# SERVICE BULLETIN

No. 638

Piper Aircraft Corporation

Inspection of Fuel Line Union Fittings

Instructions: (continued)FIGURE I

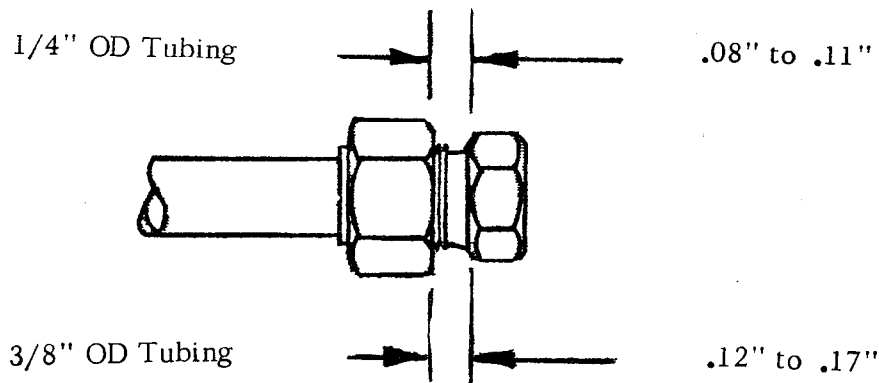
5. After the torquing of each fitting, measure the distance between the face of union nut and face of the tubing nut. See Figure I for tolerance.

1. If the fitting shows evidence of galling, or does not meet the dimensional requirements of Figure I above, or continues to leak after being tightened, as outlined in Part A, item 5, above, it shall be repaired using items 2, 3, or 4, below.
2. The recommended repair is to remove the leaking union and replace it using a standard AN fitting as outlined in AC43.13-1. (1972 issue) Paragraph 392. This will require cutting off the swaged ferrule and adding a short length of tubing.

6. If any fittings are found to be out of tolerance, refer to Part B, below.
7. After all of the unions have been checked for proper tightness and all repairs (if required) have been made, insure that the airplane is full of fuel and run engine for three (3) to five (5) minutes on each tank.
8. After engine shut down, wiggle all unions. If any fittings are found to be leaking, repairs must be accomplished as outlined in Part B, below.
9. When the system is found to be leak free, replace the side panel, carpet, access plates and seat.
10. Make appropriate logbook entry of compliance with this Service Release.
